*Technical Memo 2018-0219
February 2018*

Evaluation of the Potential for Unreasonable Impacts from the EP Well Field, Hays County, Texas

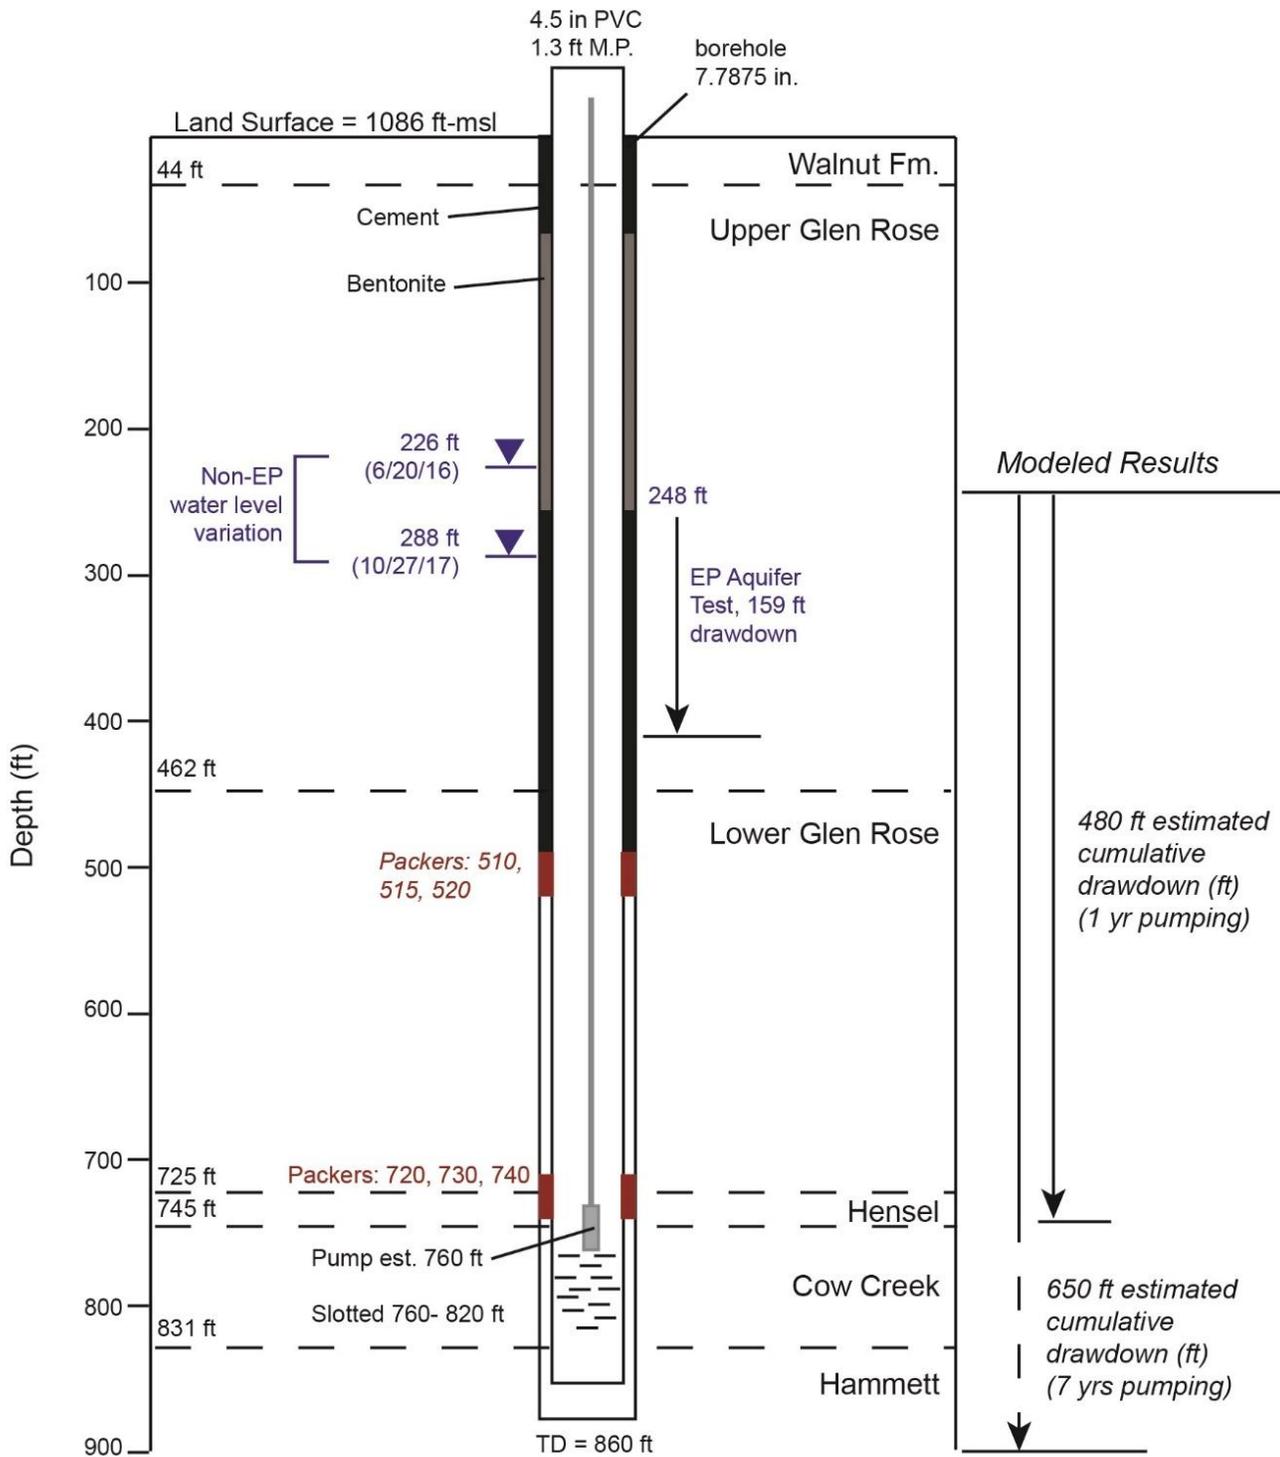
Figure 4 illustrates the measured and modeled effects of pumping in the Lowe observation well relative to hydrogeologic units and well construction. Modeled results after 1 year of pumping indicate drawdown greater than 450 ft at this location, and water levels that approach the top of the Cow Creek unit (primary aquifer unit). Modeled estimates of drawdown at 7 years are below the bottom on the aquifer and not a realistic result (see Discussion).

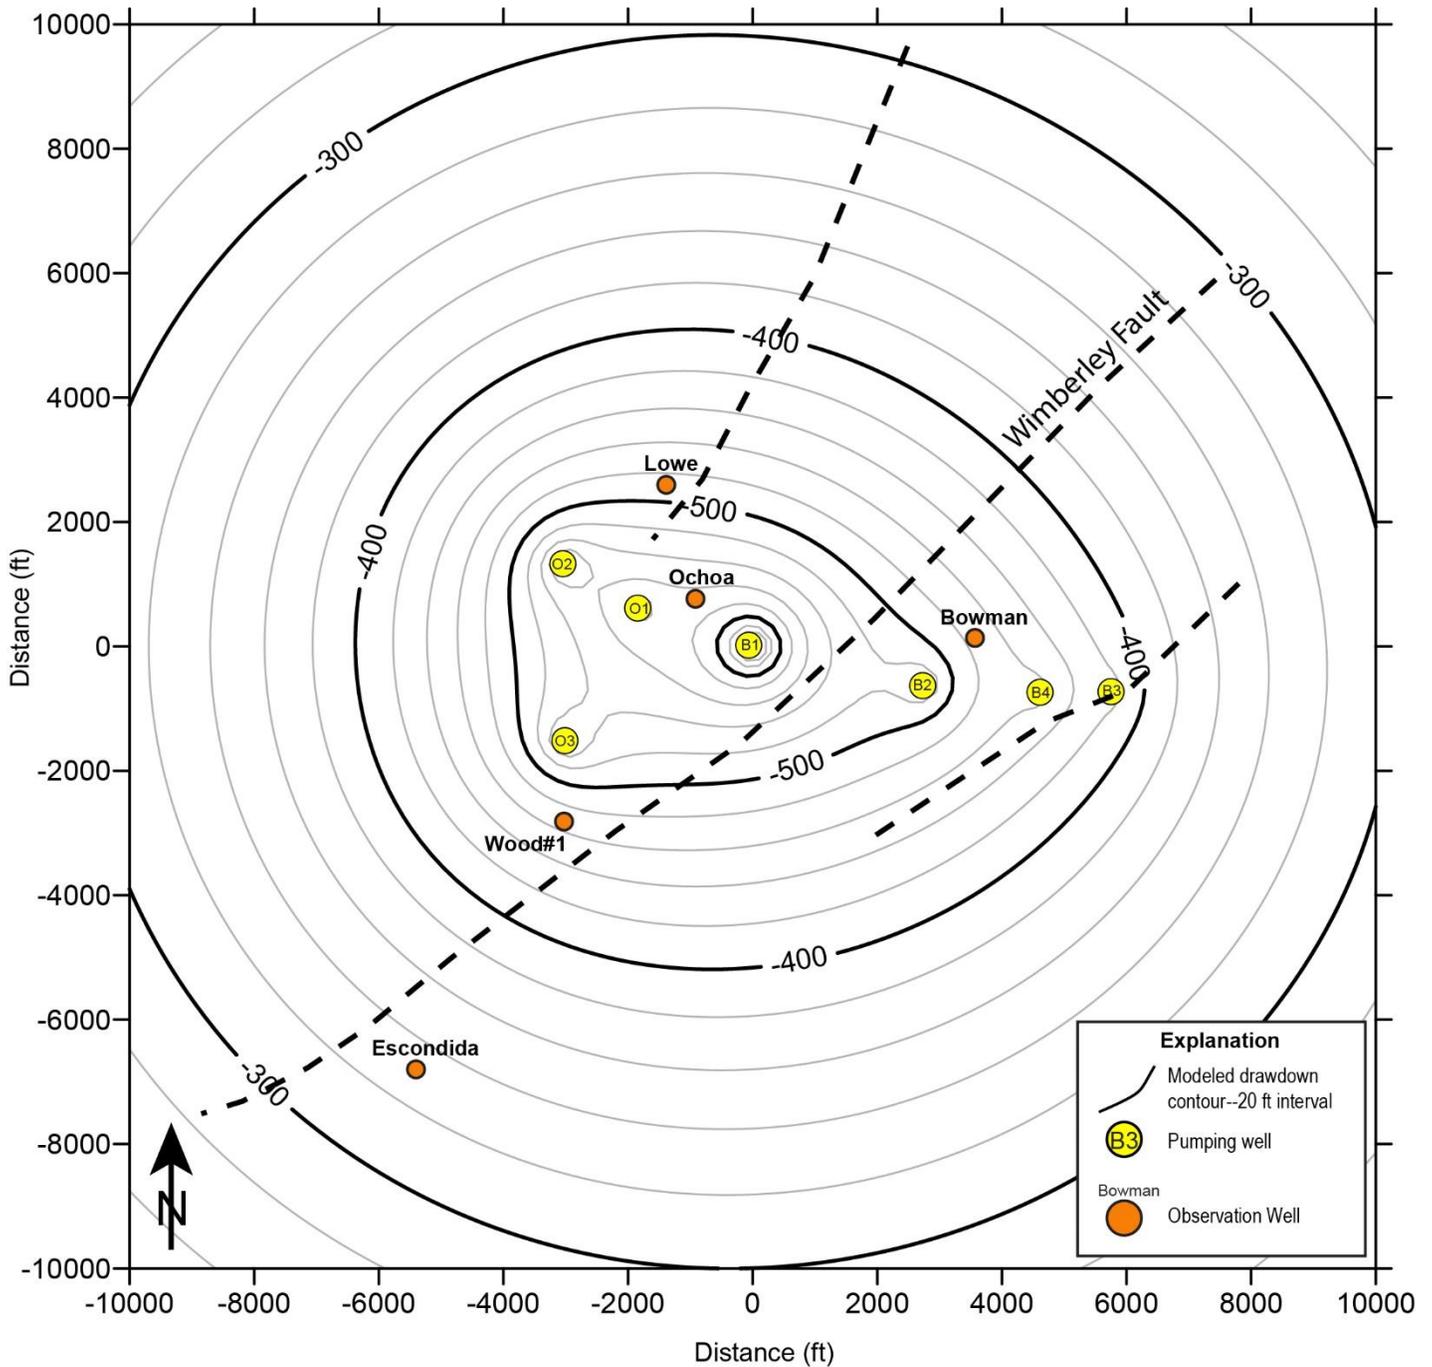
Figure 5 is a map of the distribution of drawdown from the EP pumping wells after 1 year of pumping. The Theis model was used within Aqtesolv and assumed the parameters listed in **Table 2**. Grids of drawdown from each pumping well were combined in Surfer software and contoured using its kriging algorithm. Drawdown at the five observation wells are the same as listed in **Table 4**.
